Addendum 1 for RFB 950100-01

Project Name: DOC NCCF AHU & Condenser Replacement Unit A&B

RFB #: 950100-01

Addendum No. 1 Items:

M211

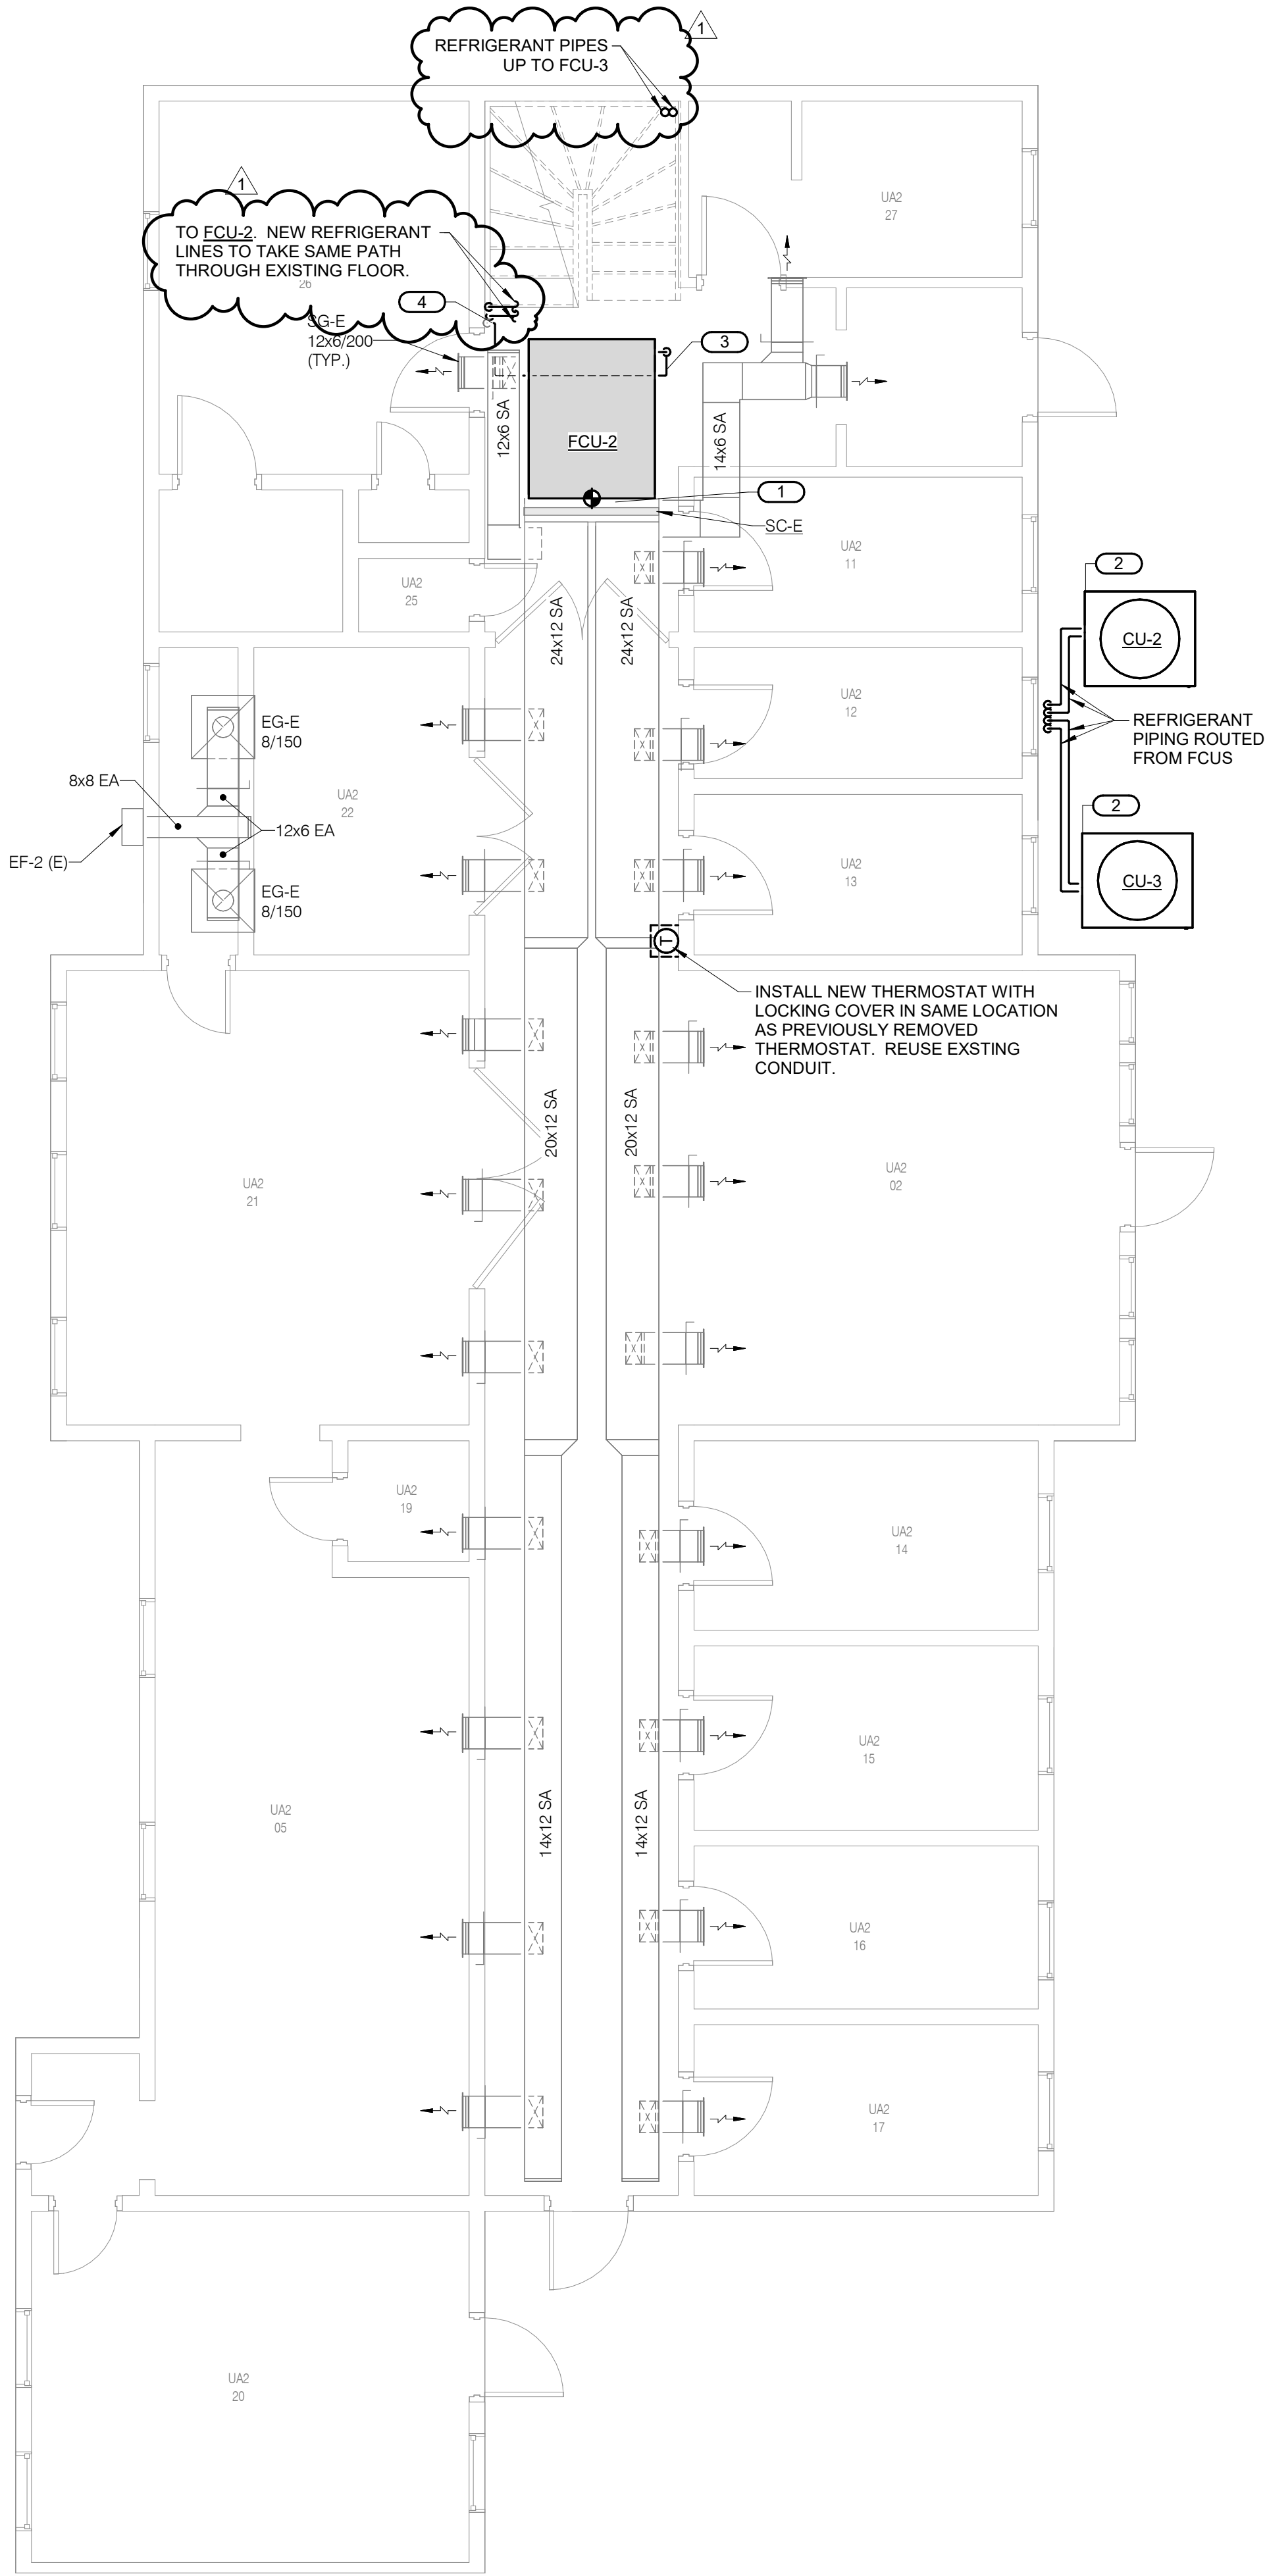
10. Drawing M210: BASEMENT PLAN - VENTILATION
 - i. REVISE new refrigerant pipe routing.
11. Drawing M211: LEVEL 01 PLAN - VENTILATION
 - i. REVISE new refrigerant pipe routing.
12. Drawing M 212: LEVEL 02 PLAN - VENTILATION
 - i. REVISE new refrigerant and steam pipe routing.
 - ii. ADD Keynote 5.
13. Drawing M500: HVAC SCHEDULES
 - i. REVISE Fan coil unit control diagram detail 1.
